**ZONING AND PLATTING COMMISSION
SITE PLAN VARIANCE REQUEST REVIEW SHEET**

CASE: SP-2014-0182D ZAP COMMISSION DATE: September 15, 2015

PROJECT NAME: Mayes Boat Dock

SUBJECT: Mayes Boat Dock SP-2014-0182D

Exhibit 6 - Proposed Fill Greater than 4 Feet Map

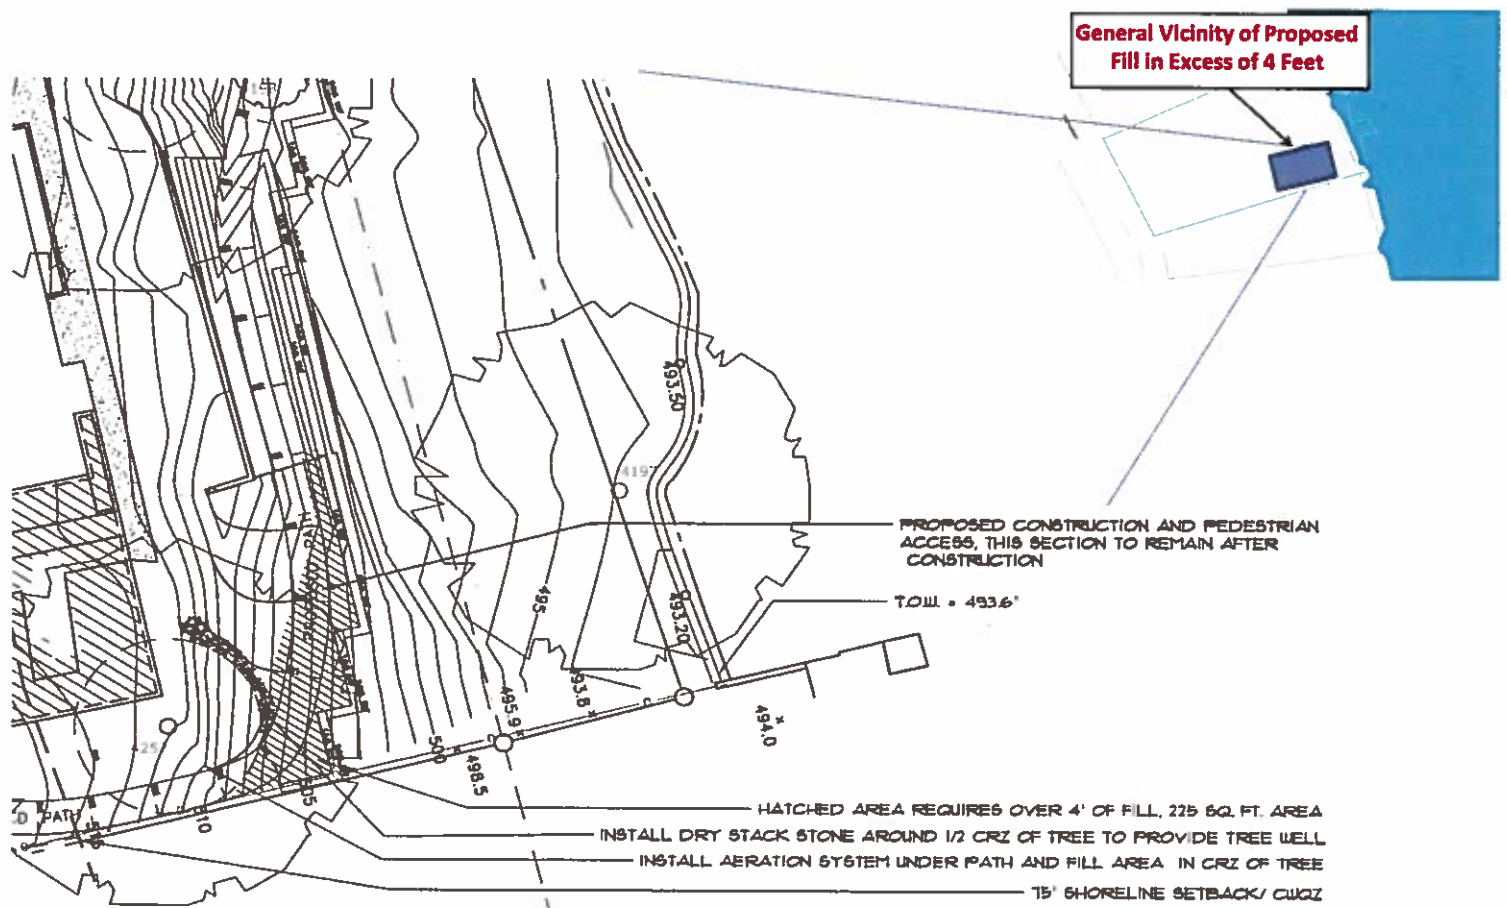
The applicant also seeks to remove a walkway and steps accessing the existing (to be removed) boat dock. In addition, the applicant seeks to install a new walkway and steps accessing the new boat dock. A portion of the proposed walkway (located at the southeast portion of the property) will require fill up to 8 feet (Exhibit 6 Proposed Fill). This fill will not exceed an area of 225 square feet.

Project: Ordinance Standard: Variance Request:	Mayes Boat Dock- SP-2014-0182DS Land Development Code Section 25-8-342(A) To allow fill up to 8 feet for the construction of a walkway to access the boat dock.
---	--

No. Boat dock access is necessary; however, access can be provided without fill in excess of 4 feet. Specifically, access can be provided on the steeper portions of the property by constructing a boardwalk type structure and on less steep portions of the property, the access can be constructed with cut and fill of 4 feet or less. Proposed fill up to 8 feet does not provide greater overall environmental protection than is achievable via a construction of a boardwalk type structure.

No. The applicant has minimized the footprint of the proposed fill over 4 feet; however, access to the boat dock can be provided while maintaining grading amounts of 4 feet or less. Fill in excess of 4 feet does not represent the minimum change necessary to avoid the deprivation of a privilege given to other property owners and to allow a reasonable use of the property.

There is no Staff recommendation for the fill variance request (variance 2). Review staff and the applicant were not aware that the proposed fill variance did not meet the findings of fact until very late in the review process due to a mis-communication with the Environmental Officer. As a result, the Environmental Officer agreed to take this variance forward with no recommendation.
